RE: Lucasey Manufacturing  
2744 East 11<sup>th</sup> Street  
Oakland, California 94601  
SLIC Case RO0002902  
Clearwater Group Project # FB022I

**Subject: SLIC Case RO0002902, Lucasey Manufacturing,  
2744 East 11<sup>th</sup> Street, Oakland, California**

Clearwater Group (Clearwater) on behalf of Lucasey Manufacturing (Client) is writing in response the Alameda County Environmental Health Services (ACEH) letter, dated August 23, 2007.

**PROPOSED RECOVERY TEST WELL LOCATIONS**

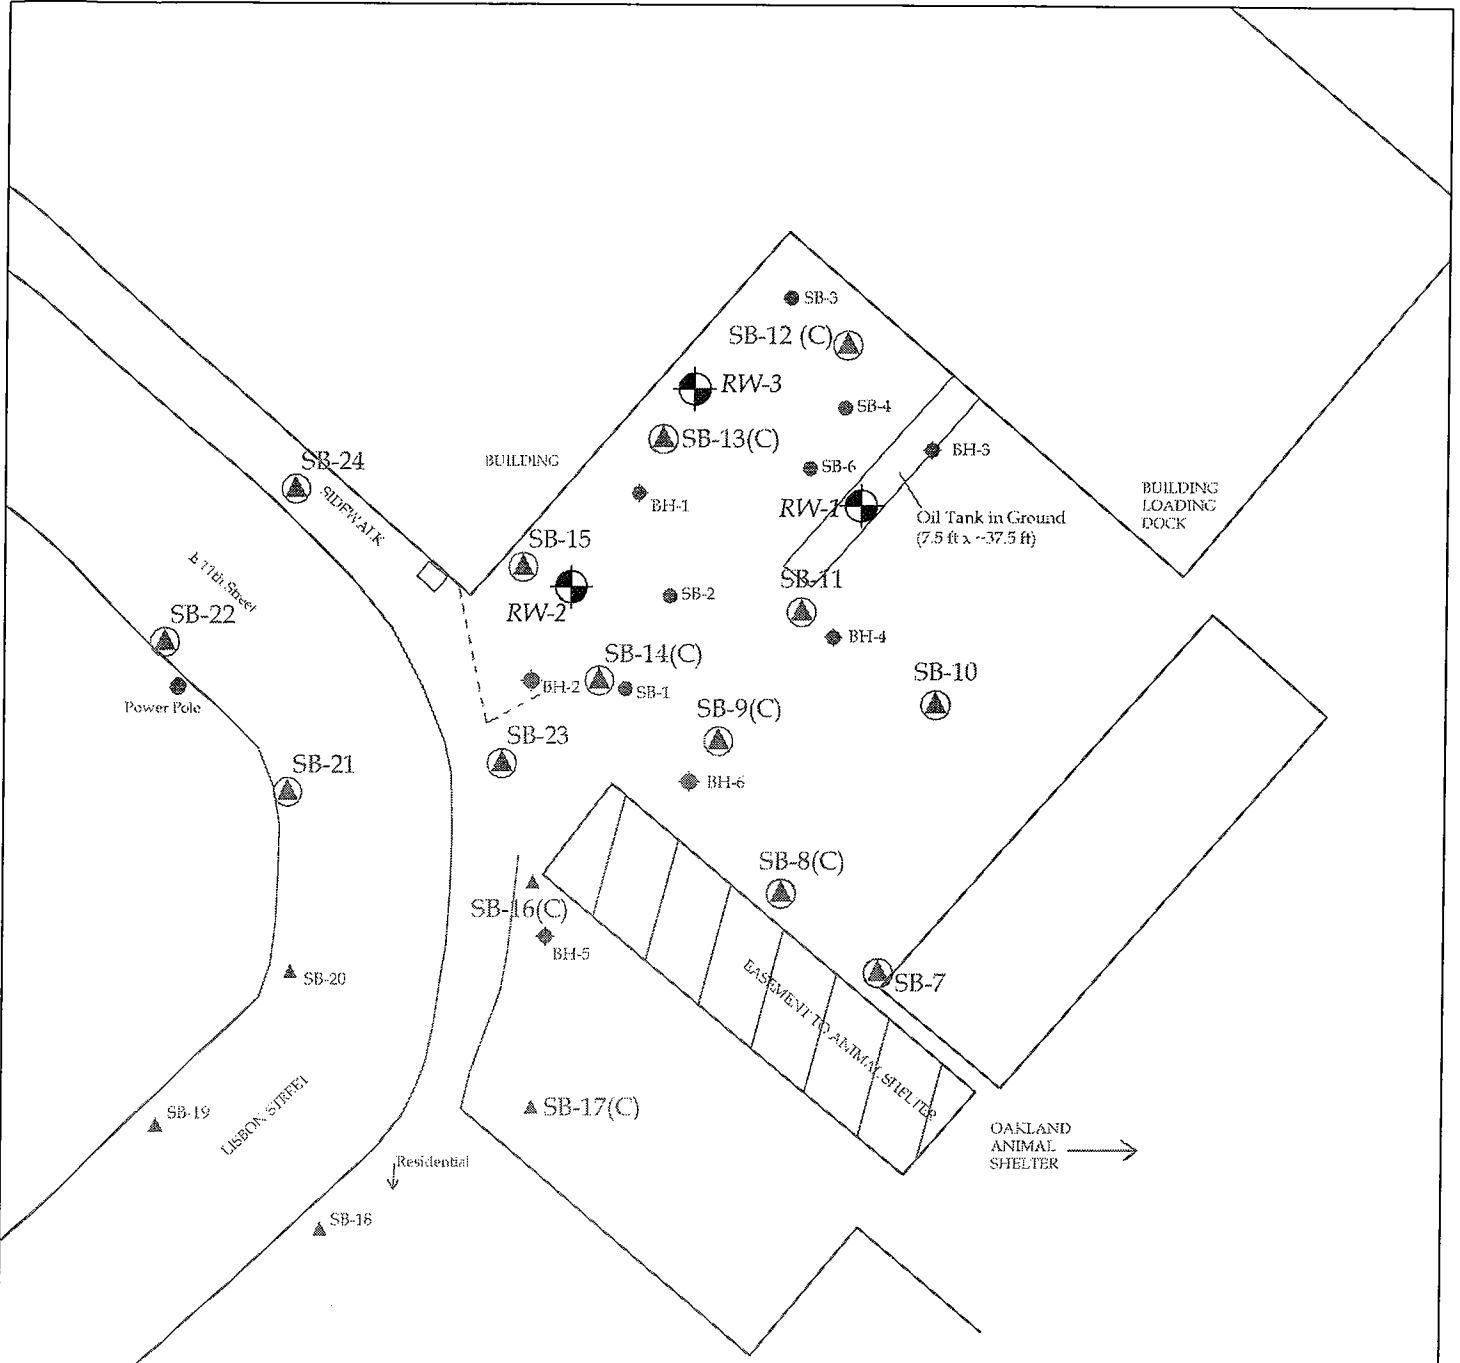
## **3. Proposed Recovery Well Locations**

Clearwater will adjust the location of the recovery well RW-2 so that it is placed within the "Estimated Free Product Boundary". We believe RW-1 should remain in its current location as it will provide valuable information on the existence of the Underground Storage Tank (UST). Based on your request of August 23, 2007, a third recovery well will be proposed within the "Estimated Free Product Boundary". (Figure 5 attached)

<b>GEOPHYSICAL SCREENING MAP</b> Lucasey Manufacturing 2744 E 11th Street Oakland, California	<b>CLEARWATER GROUP</b>		
	Project No. <b>FB022E</b>	Figure Date <b>4/06</b>	Figure <b>7</b>

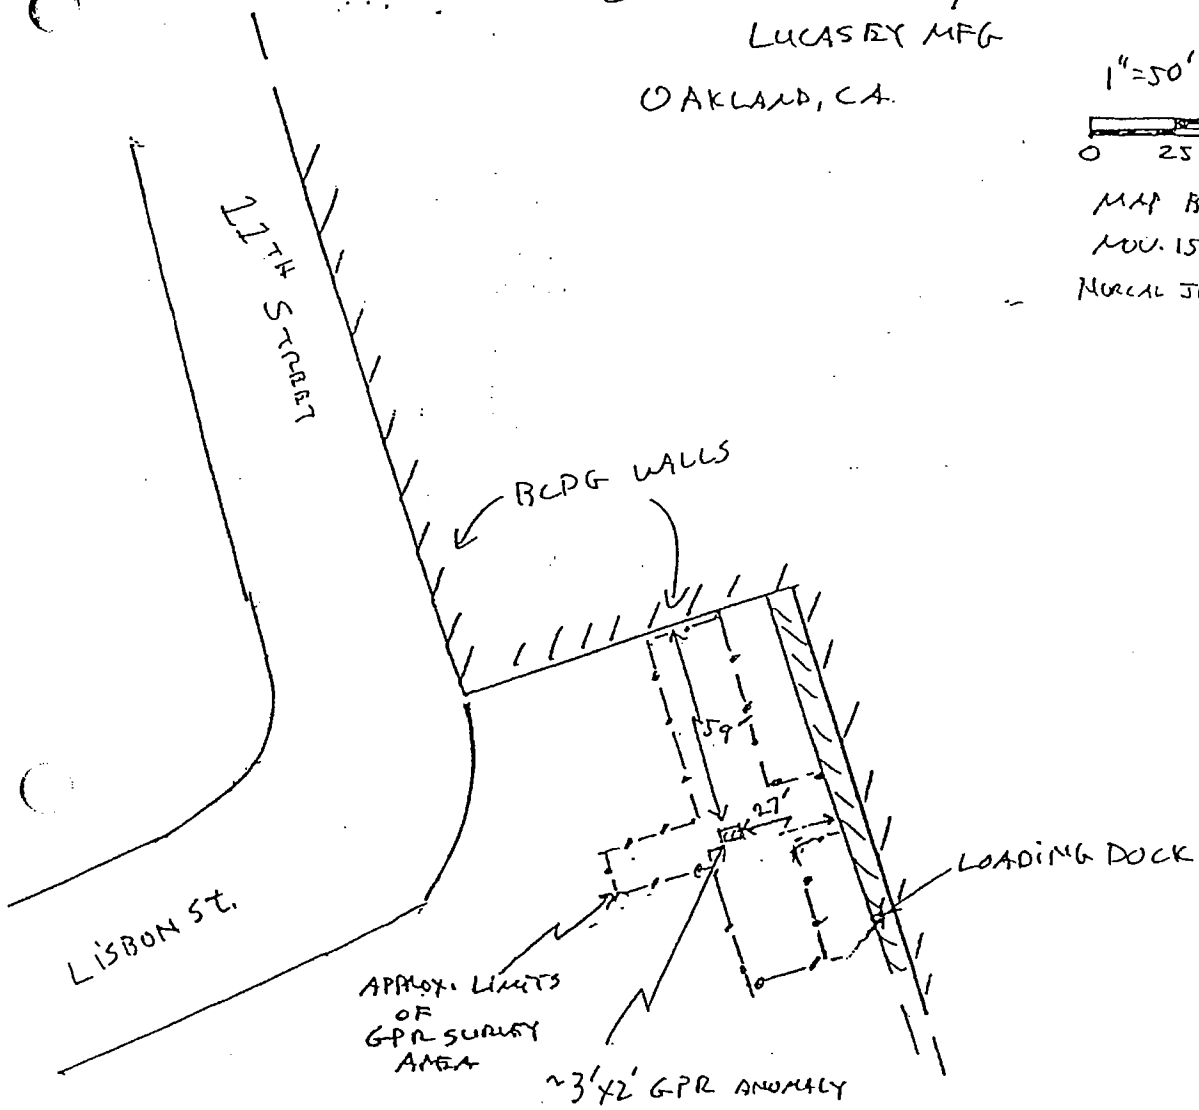
#### **6. Underground Storage Tanks**

Norcal Geophysical (Norcal) of Cotati, California, conducted a Ground Penetrating Radar (GPR) scan around the estimated location of the UST on November 15, 2005. A hand-drawn map showing the area scanned was presented in the Soil and Groundwater Investigation Work Plan as figure 7 and dated April 25, 2006. This information was also presented on page 4 and figure 4 of the Soil and Groundwater Investigation Report, dated March 7, 2007. Norcal did not produce a detailed report for this event, however Clearwater staff was onsite to document the GPR scan. If necessary we could get Norcal to supply a letter stating that they conducted this work. The geophysical utility mapping conducted by Subtronic Corporation (Subtronic) of Concord, California on November 20, 2006, was related to utility location and not UST location. (the Norcal GPR survey map is attached)
